Building Surveyor plan
 Grant pass- Nathall

PLAN
SHOWING ADDITIONS ON
PLOT NO 60 SHEET E3
RANCHORE QUARTER

NOTICE UNDER SECTION 96 OF ACT III OF 1901.

PLAN SHOWING ADDITIONS & ALTERATIONS TO BE MADE ON SURVEY N° 12-B-12

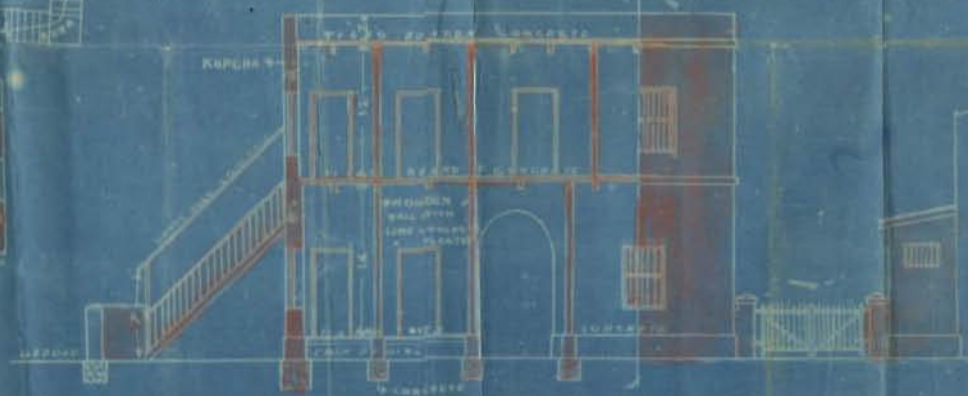
There are no special
circumstances not revealed
on the plan.
The proposed out houses
will certainly block the
light & air to the bungalow
and the prevailing wind, which is
South East, will take the air
from the kitchen, servant quarters
& stable into the bungalow

In reply to my application, the Engineer states that permission to build can not be granted as the proposed out-houses will block the passage of light and air.

I beg to point out, with regard to No: 1, that there is a space of about 10 feet between the proposed out-houses and the bungalow, and I trust you will agree with me that for a house with one story, a passage of 10 feet is more than ample for light and breeze, particularly as there is a large open compound in front and rear. It seems to me strange that where-as through out in the Locality building plans should be passed with open space amounting to only about 1/10th area of the plot, the Engineer should think fit to disapprove a plan with such a lot of open space. I may add that my plan is in accordance with the requirements of the rules and byelaws of the Municipality and I regret that it should be rejected on no definite grounds but simply by an arbitrary and general ruling of the Engineer.

With reference to your application dated 25th ultimo with a set of plans for building out-houses etc. on plot No. 60, E-3 Runchore Quarter I have the honour to inform you that permission to build stables and out-houses in the position shown can not be granted as it will block the light and air to the bungalow. The out buildings may be built in the position shown ^{in red} on the plan thus:-

Proposed outhouse will render the bungalow insanitary as it will interfere with the existing ventilation. It appears that the plot is to be subdivided which will be really insanitary

Under the restrictions imposed by the conditions of sale the scheme of building should not be approved and the owner has been so informed.

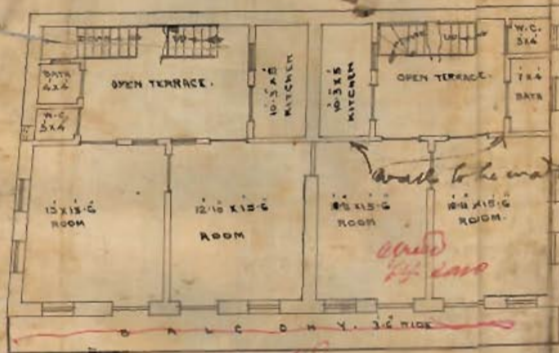
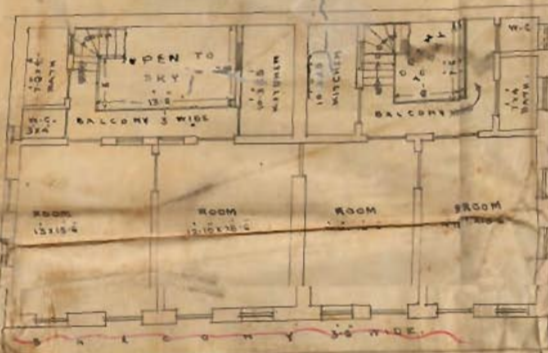
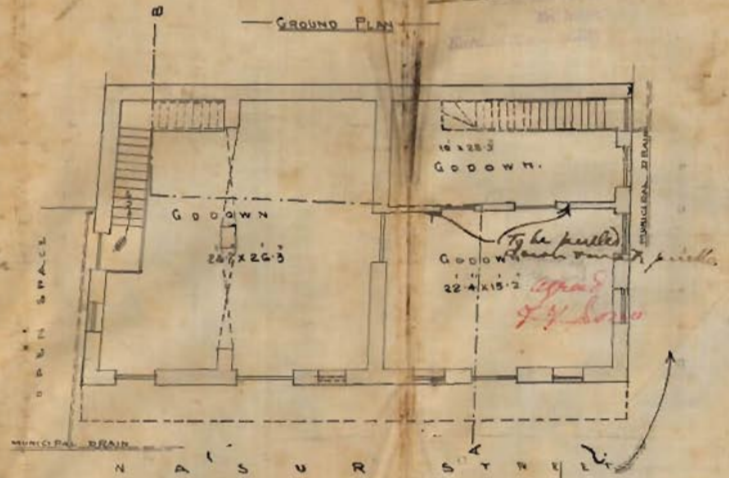
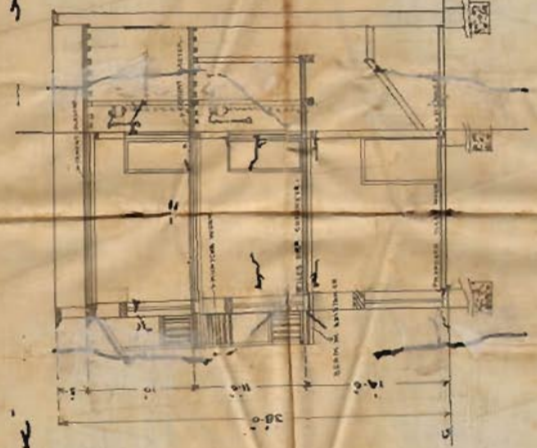
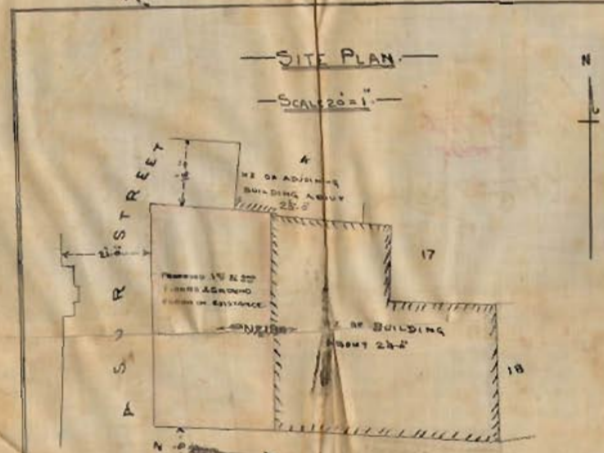
With reference to their letter dated 8th instant with 2 copies of plans for the additional 2nd floor to be built on plot No. 19, A-12 Naser Street Muchi Meani Quarter Messrs Haji Thawar Tharia and sons are informed that their statement is incorrect, there is no balcony to the house, only beams projecting, which do not constitute a balcony. Before sanction to erect an additional storey can be granted the present walls must be made secure. The lintel over the windows must be removed and arches put in to carry the ~~weight~~ extra weight. the katcha partition walls on the ground floor must be removed and packa one substituted.

With reference to your memo No. 2, 3578 dated 23rd instant. We beg to state that although we have every right to build balcony over the beams projected for the purpose in front of our house on plot No. 19 A-12 Kachar Street Muechi Buzi Quarter which stand there for the last more than years but looking to the amount of delay which takes in the Municipality for disposing of such matters we have for the present given up the idea of building the balcony in question and have therefore deleted the same from the plans.

Submitted to the
Chief Engineer for order.
The balcony should
not be allowed.
And the plan should be
coloured as instructed
to the license architect.

In continuation of this office No.E.2597 dated 24/25th instant, Messrs Haji Thawar Tharia and sons owners of plot No.19, A-12, Macni Bani quarter are requested to delete the balcony and return the same with two extra copies which will be returned to him duly signed by the Undersigned as approved for submitting to the City Deputy Collector as required by the Collector.
